Access Compliance Report

Public Rights-of-Way

(Curb Ramps)

Intersection ID: 12629	Main Street: E_6TH_ST	Cross Street: N_DAVIDSON_ST	Location: NE
ADA ID: 686C5DE7D602	Ramp Type: Perp	Initial Pass/Fail: Fail	Overall Compliance: No
Severity Score: 22.5			
Codes/Mitigation Info/Possible Solution		Field Measurements/Component Compliance

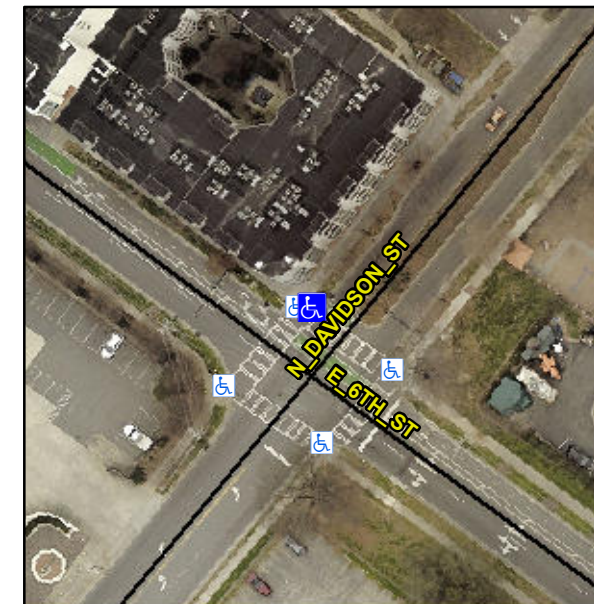
Not Found, R304.5.1, R304.2.2

Compliance	Description	Data	Compliance	Description	Data
N/A	Ramp Length (in)	68.5	No	Ramp Slope (%)	8.8
No	Ramp Width (in)	46.0	Yes	Ramp XSlope (%)	2.4
N/A	Flare Type LT	N/A	N/A	Flare Type RT	N/A
N/A	Flare Slope LT (%)	N/A	N/A	Flare Slope RT (%)	N/A
N/A	Flare Traversable LT?	N/A	N/A	Flare Traversable RT?	N/A
N/A	Landing Length (in)	N/A	N/A	DWS Provided?	N/A
N/A	Landing Width (in)	N/A	N/A	DWS Contrast?	N/A
N/A	Landing Slope (%)	N/A	N/A	DWS Length (in)	N/A
N/A	Landing X Slope (%)	N/A	N/A	DWS Full Width?	N/A
N/A	Landing Curb? (Y/N)	N/A	N/A	DWS Offset (in)	N/A
N/A	Shared Landing?	N/A			
N/A	Gutter Ponding?	N/A	N/A	Gutter Slope (%)	N/A
N/A	Gutter Lip Ht (in)	0.5	N/A	Gutter X Slope (%)	N/A
N/A	Painted X Walk1?	Yes	N/A	Painted X Walk2?	N/A
	X Walk 1 Direction	To SE		X Walk 2 Direction	N/A
N/A	X Walk 1 Width (in)	112.0	N/A	X Walk 2 Width (in)	N/A
	X Walk 1 Slope (%)	3.6		X Walk 2 Slope (%)	N/A
	X Walk 1 X Slope (%)	3.6		X Walk 2 X Slope (%)	N/A

Remove & Replace Entire Ramp.
